Access Compliance Report

Public Rights-of-Way (Curb Ramps)

Intersection ID: 5272	Main Street: CHINEMIST_CT	Cross Street: FROSTMOR_PL	Location: NE
ADA ID: A505ED10FA1C	Ramp Type: Directional1	Initial Pass/Fail: Fail	Overall Compliance: No
Severity Score: 48.75			
Codes/Mitigation Info/Possible Solution		Field Measurements/Component Compliance

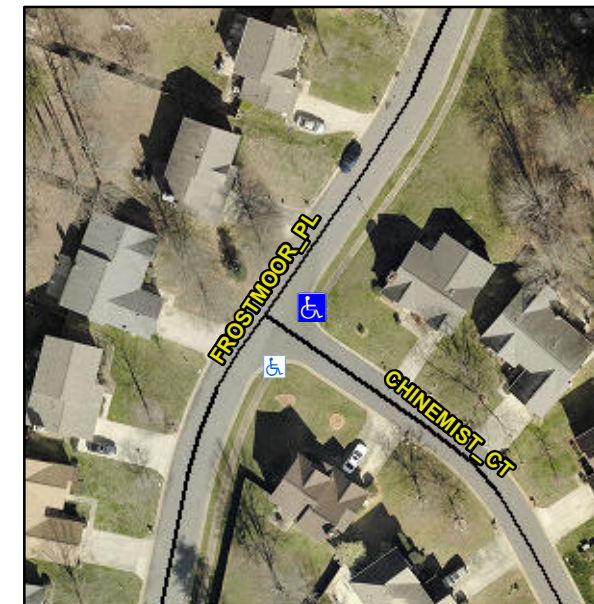
R304.5.1, R304.2.2, R302.7

Compliance	Description	Data	Compliance	Description	Data
N/A	Ramp Length (in)	26.0	N/A	Grade Break?	N/A
No	Ramp Width (in)	43.0	N/A	Grade Break Slope (%)	0.0
No	Ramp Slope (%)	20.0	N/A	Grade Break XSlope (%)	0.0
Yes	Ramp XSlope (%)	0.6			
N/A	Flare Type LT	N/A	N/A	Flare Type RT	N/A
N/A	Flare Slope LT (%)	N/A	N/A	Flare Slope RT (%)	0.0
N/A	Flare Traversable LT?	N/A	N/A	Flare Traversable RT?	N/A
N/A	Landing Length (in)	0.0	N/A	DWS Provided?	N/A
N/A	Landing Width (in)	0.0	N/A	DWS Contrast?	N/A
N/A	Landing Slope (%)	0.0	N/A	DWS Length (in)	N/A
N/A	Landing X Slope (%)	0.0	N/A	DWS Full Width?	N/A
N/A	Landing Curb? (Y/N)	N/A	N/A	DWS Offset LT (in)	N/A
N/A	Shared Landing?	N/A	N/A	DWS Offset RT (in)	N/A
N/A	Gutter Ponding?	0.0	N/A	Gutter Slope (%)	N/A
N/A	Gutter Lip Ht (in)	0.0	N/A	Gutter X Slope (%)	N/A
N/A	Painted X Walk1?	No		Road Slope (%)	7.1
	X Walk 1 Direction	To W		Road X Slope (%)	0.2
	X Walk 1 Width (in)	N/A		Clear Space?	N/A

Remove & Replace Entire Ramp.
